Design Update

Non Material Amendment Supporting Document

A283-MCO-XX-XX-DS-A-04001

THE REPUBLIC

2.1 Proposed Design for Introduction of Frit on all the glazing on the Southern Elevation

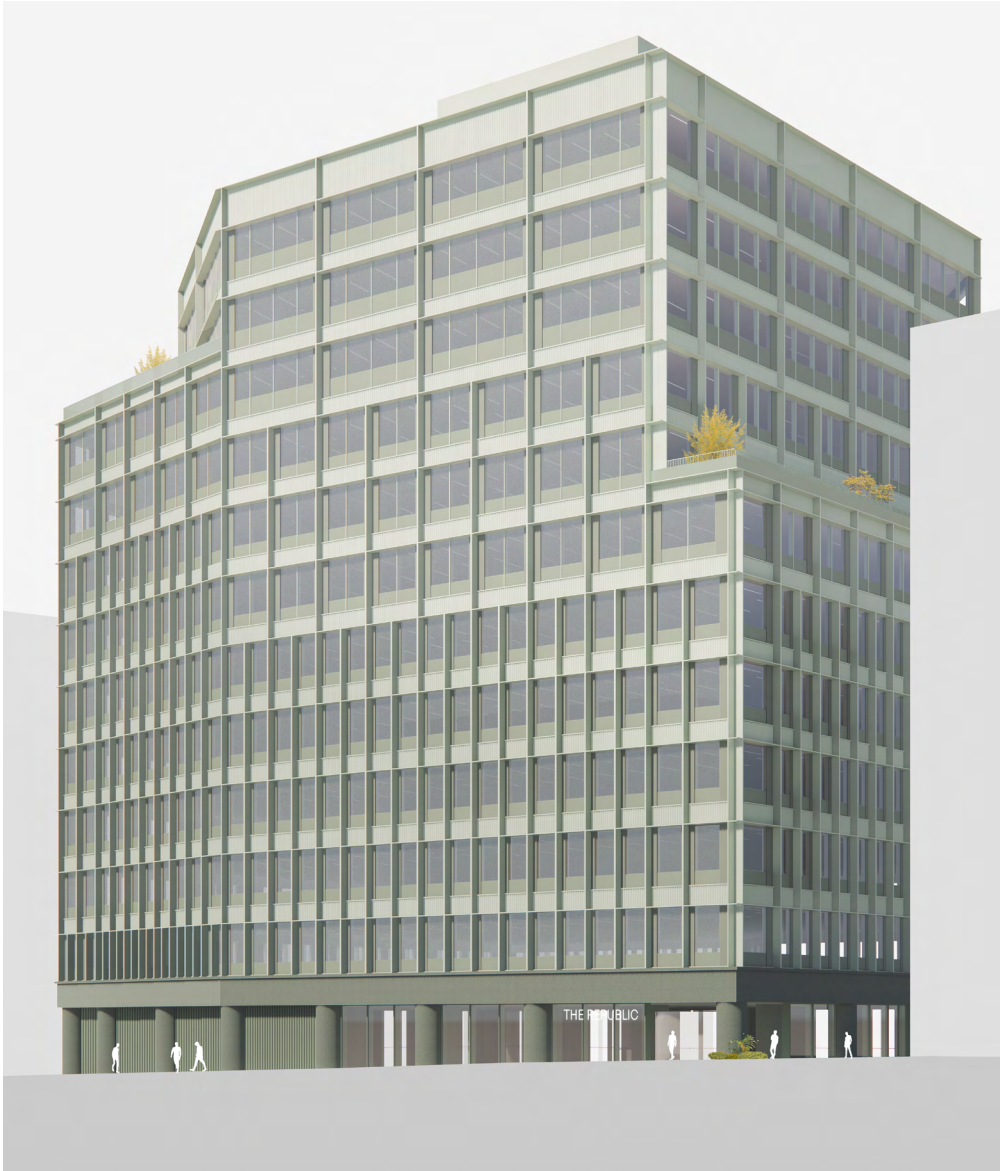
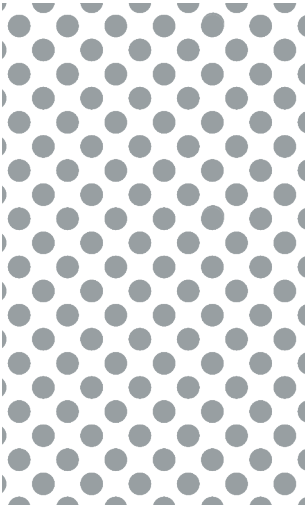
The proposal is for Ceramic frit applied to the whole Southern elevation;

- + 3mm (diameter) dots at 35% are proposed
- + RAL 7040 proposed externally (see below at 1:1)
- + No frit at ground / mezzanine level

2.2 Proposed Ground Floor Door Alterations

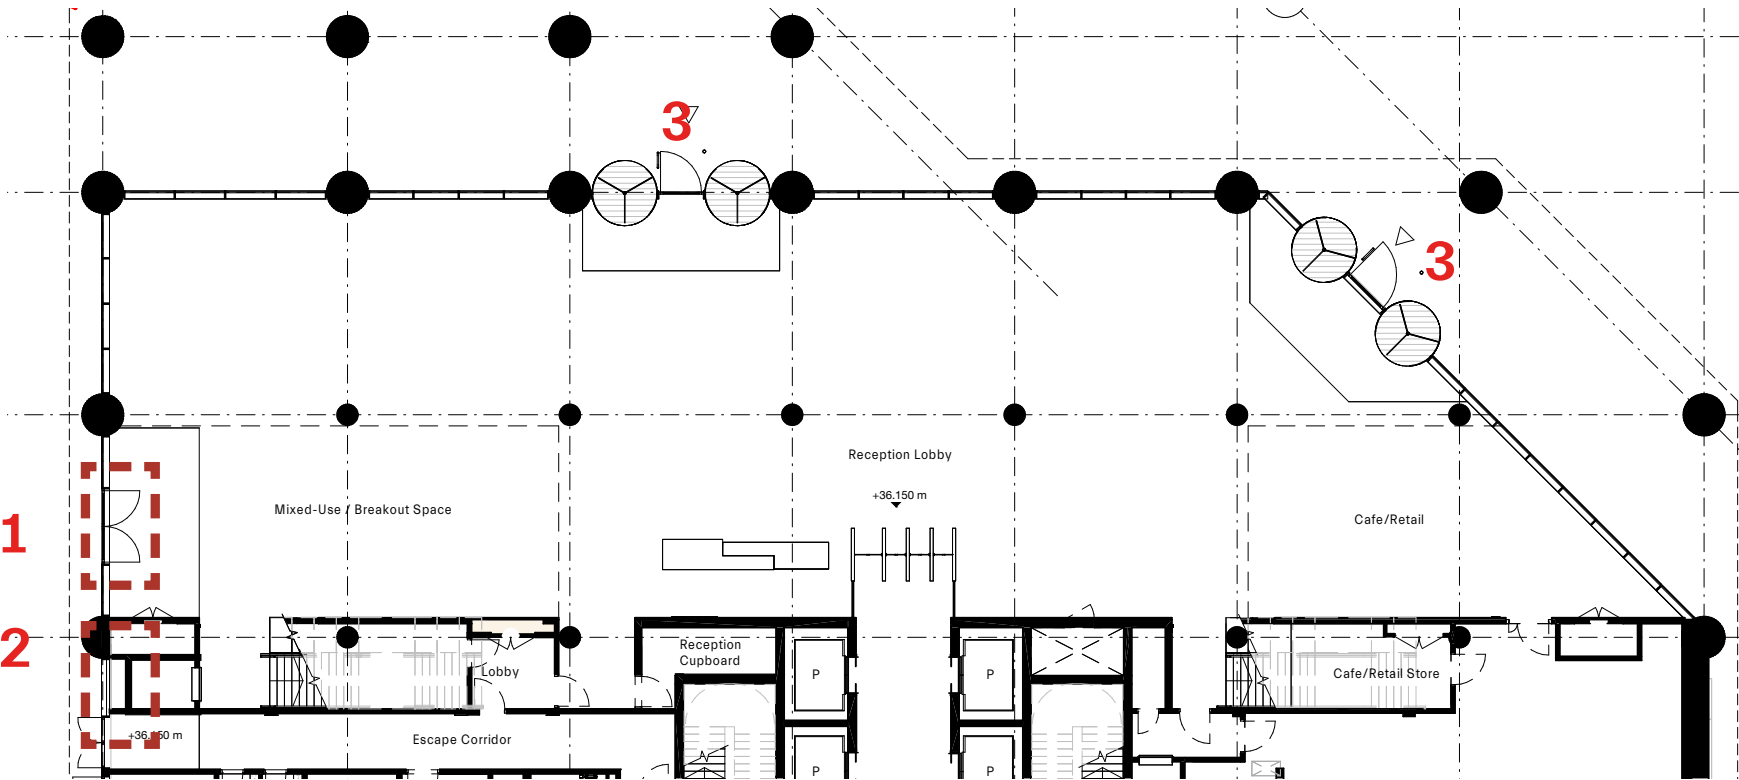
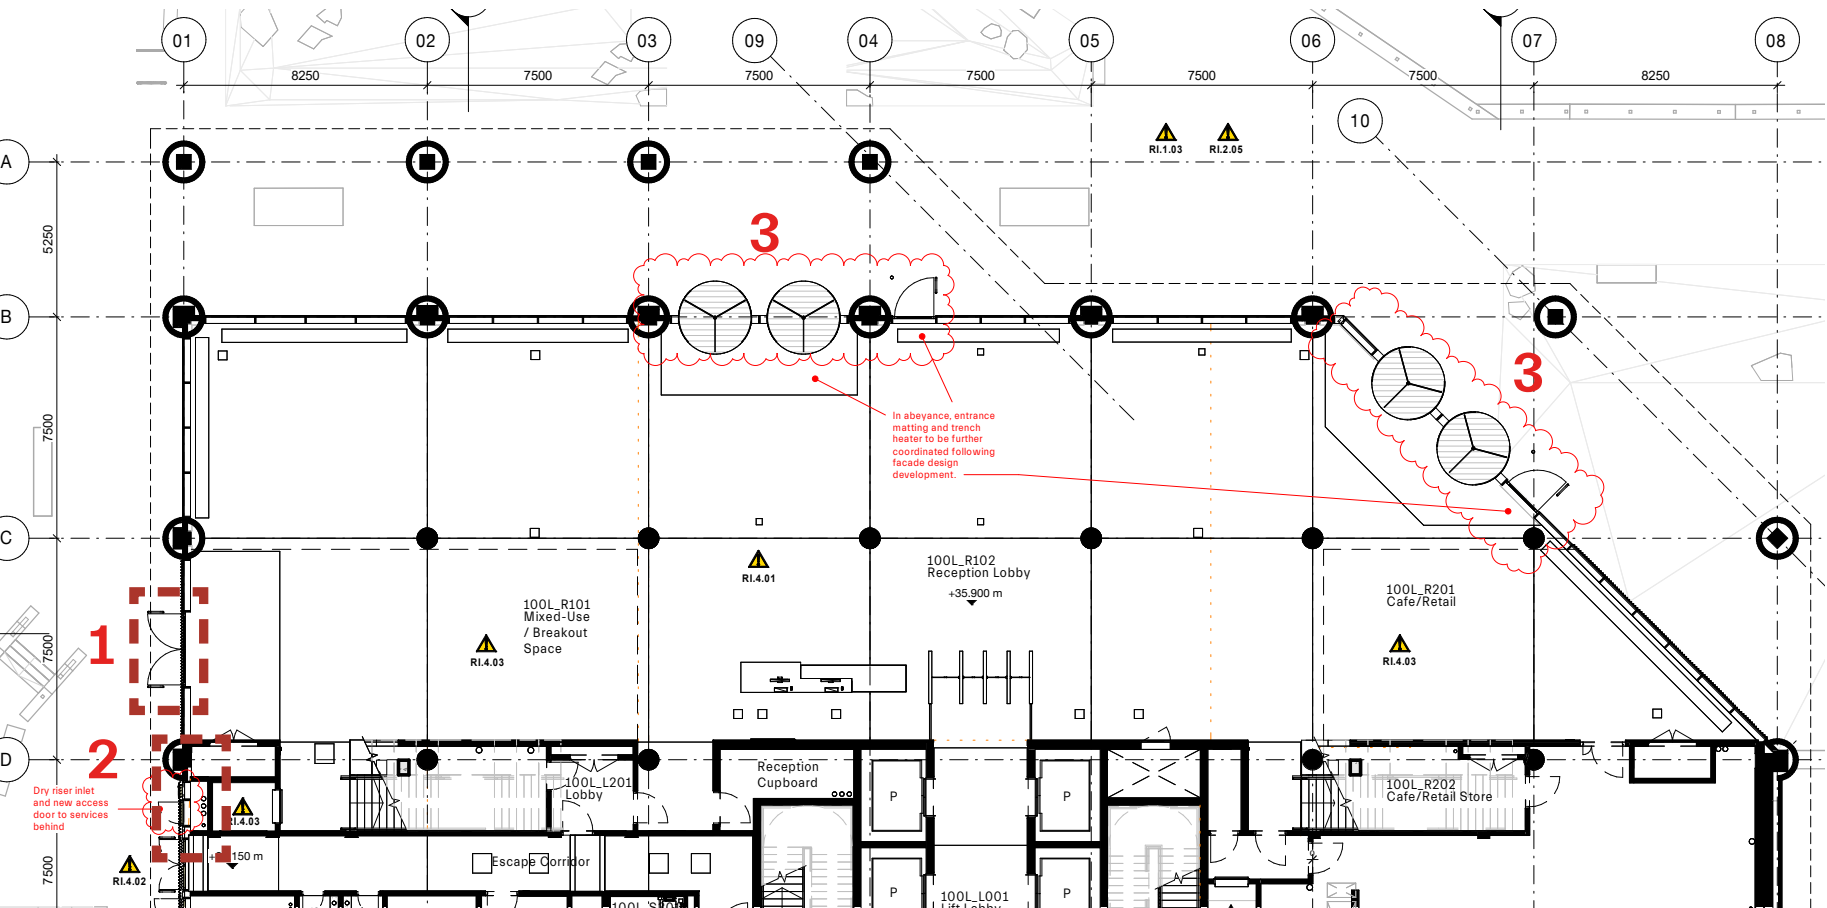
1. Double doors adjusted from an inward opening door to an outward opening door as a more efficient means of escape.
2. Outward opening access door to services riser introduced
3. The centrally located pass door is not achievable with the curtainwall system proposed, without significant impact on structure and facade grid. Therefore the pass door has been relocated next to the revolving doors, as shown adjacent, and elevated on the next pages.

2.3 Proposed Ground Floor Door Alterations - North

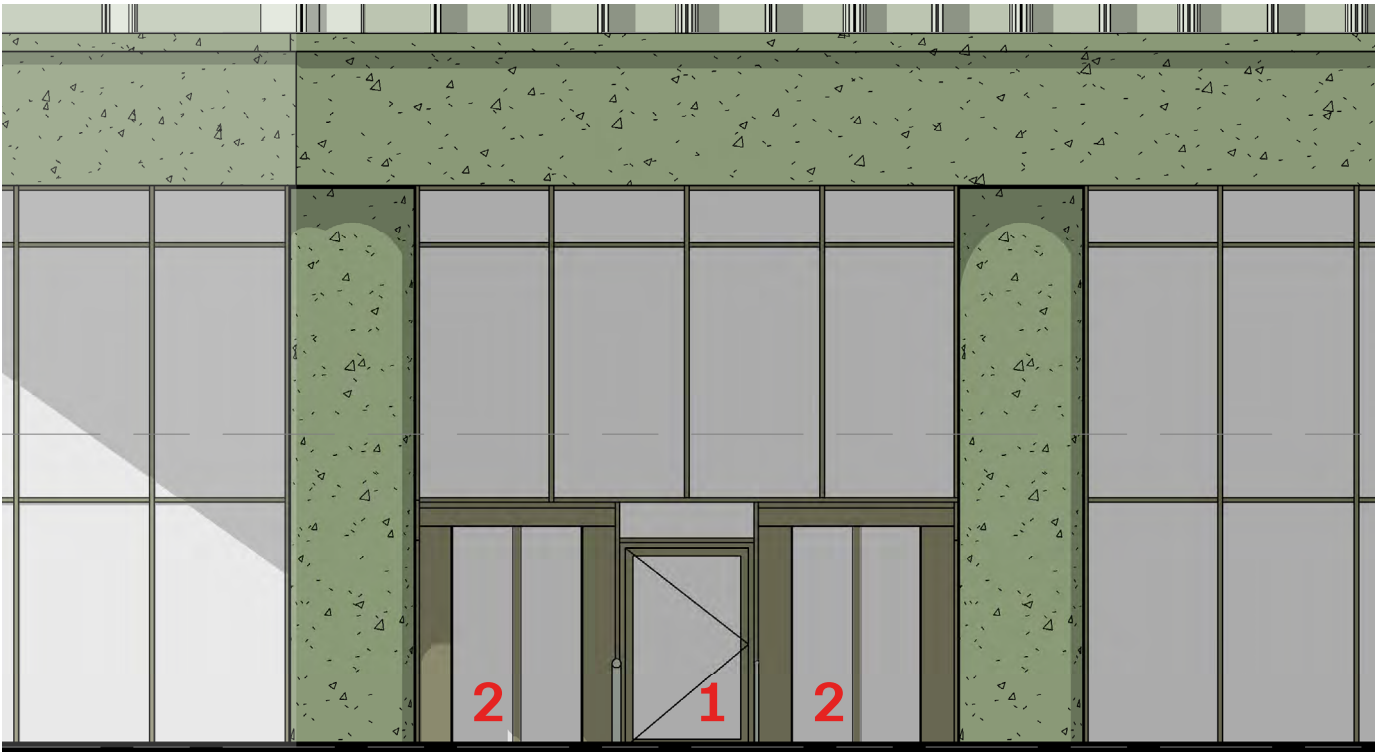
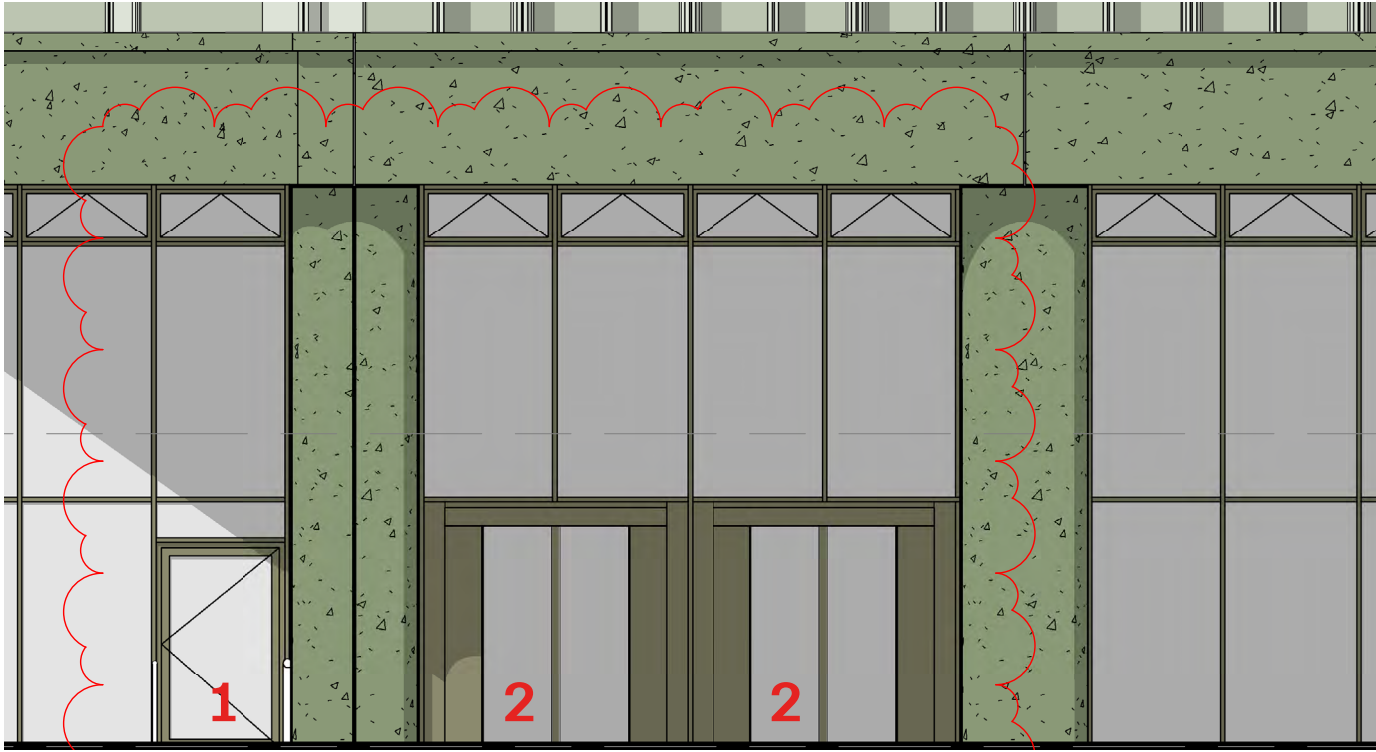
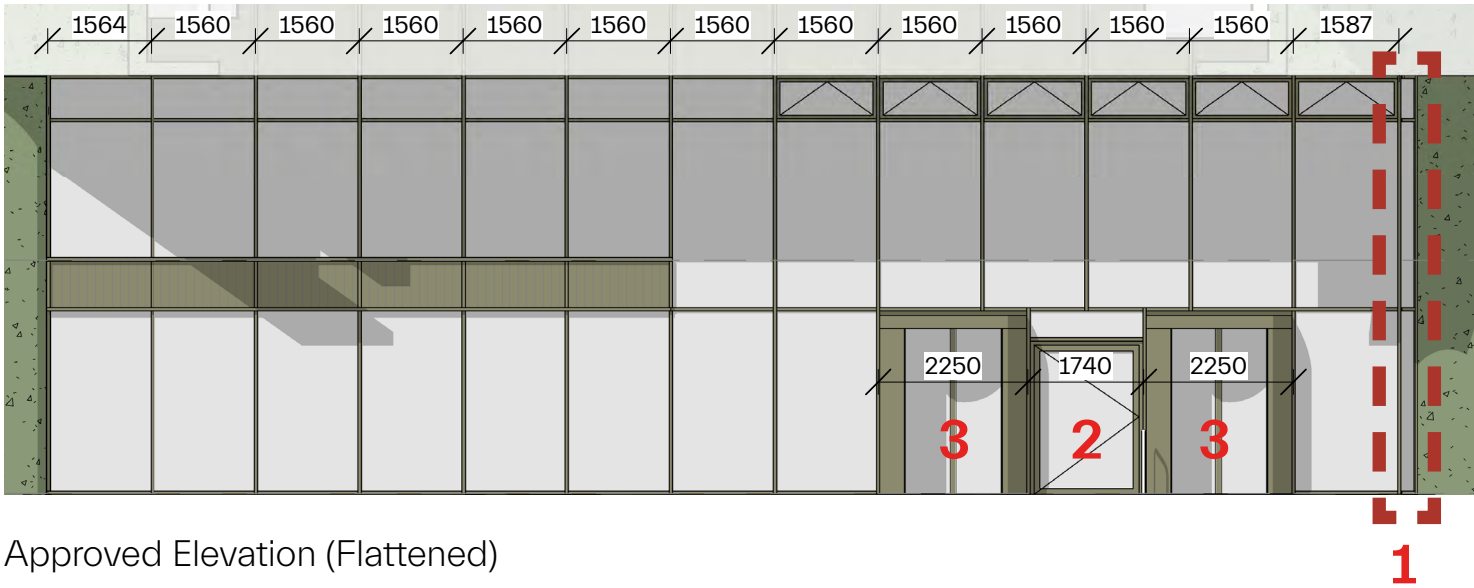
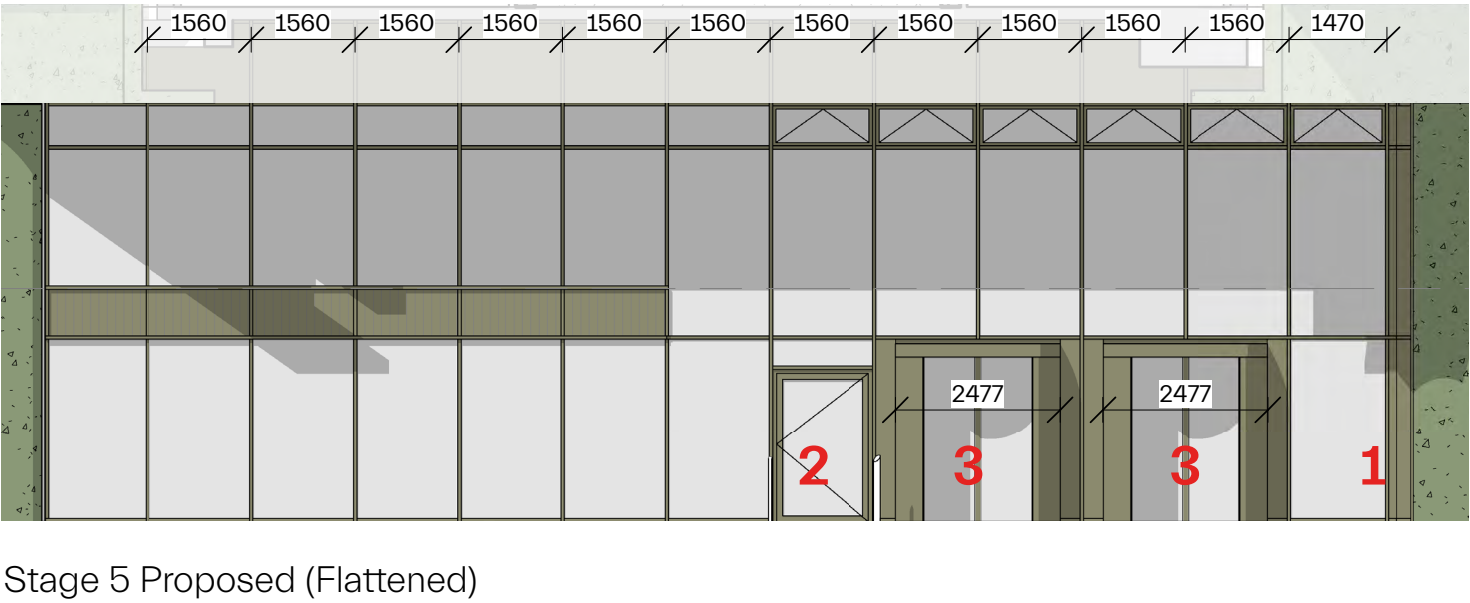
During Stage 5, FKN identified that maintaining the Stage 4 design intent would require additional steel substructure due to the transfer of glass loads onto the curtain wall mullions. To avoid this and retain the original mullion layout, the following changes are proposed;

1. To move pass doors adjacent to the revolving doors
2. To increase the size of revolving doors.

The option of increasing pass door height has been explored, including adjusting frame depths. However, door dimensions are constrained by test certifications, hinge load limits, and opening force requirements, meaning frame changes alone cannot achieve taller doors.

Achieving greater door height would require relaxing key performance criteria, including barrier load, burglar resistance, glass load, and weather performance.

This would compromise Secure by Design compliance and increase the risk of weather ingress. Therefore, the reduced door height within the current façade grid is considered the most appropriate solution at this stage.

2.4 Proposed Ground Floor Door Alterations - North East

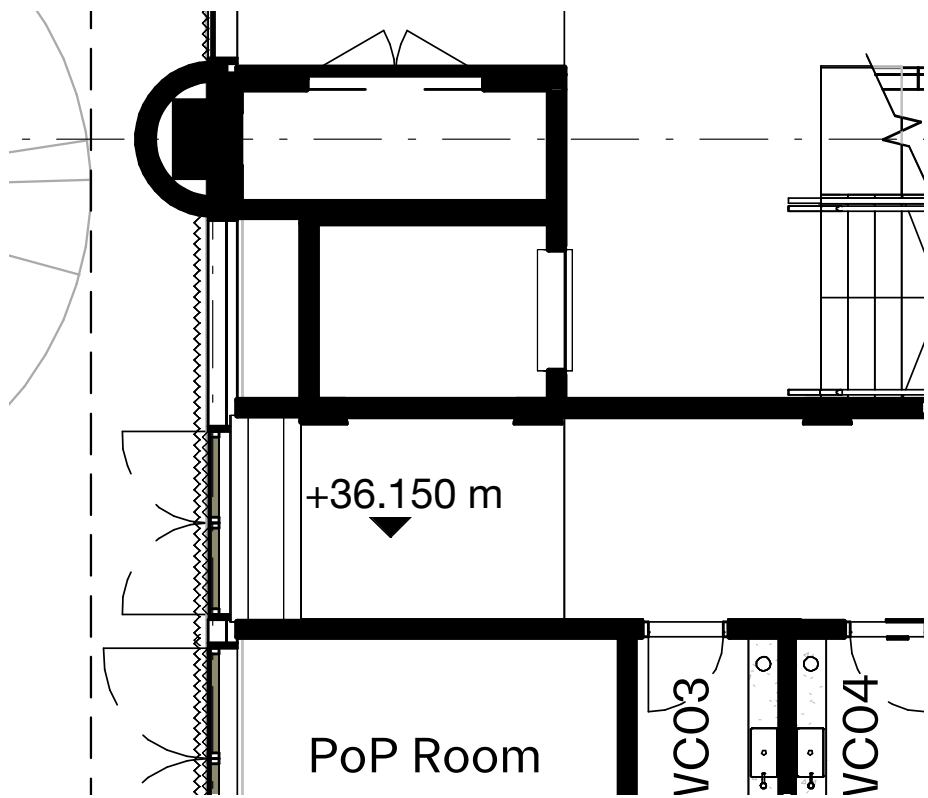
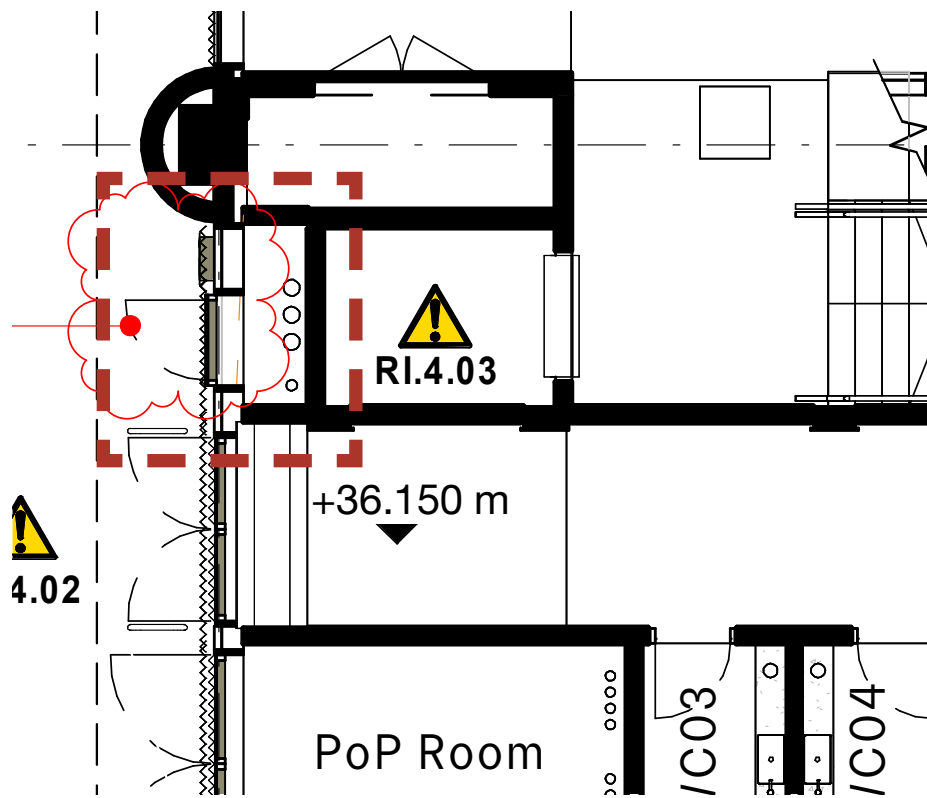
In addition to the changes outlined in relation to the pass door arrangement, FKN informed us about fabrication issues in relation to a slender piece of glass (outside fabrication dimensions) within the original facade setting out, as highlighted above.

1. A change from glazing to PPC metal to match the facade generally, in this location only.
2. To move pass doors adjacent to the revolving doors
3. To increase the size of revolving doors.

2.5 Proposed Door Alterations - West Riser Door

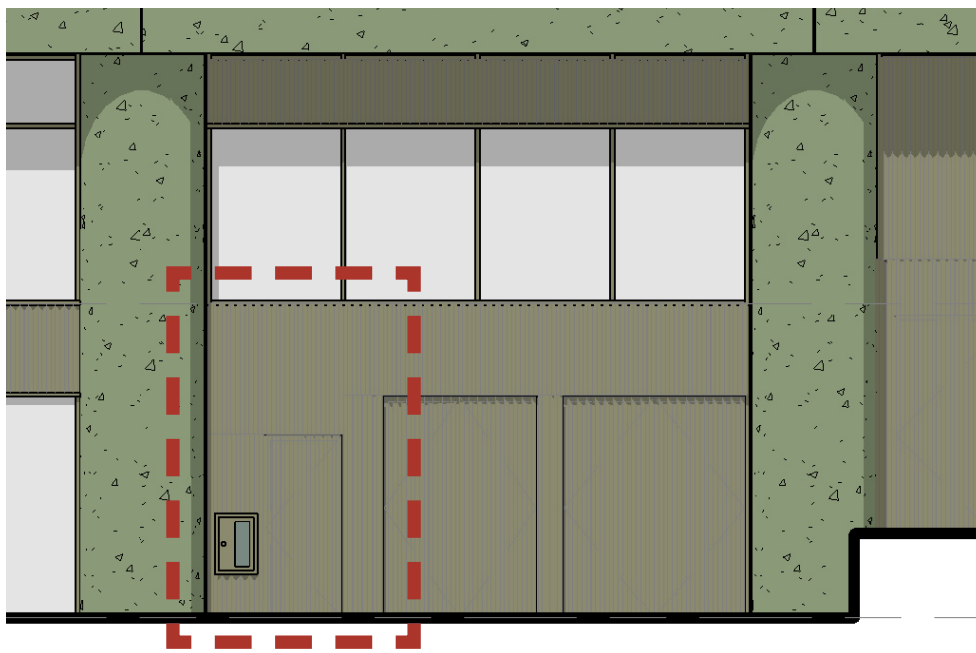
- The following changes are proposed to the West elevation;
1. New single access door (water meter and isolation valve).
Corrugated door flush with rest of cladding, minimum visual implications to the approved design.
 2. Dry riser inlet for adjacent fire fighting access route from GF.
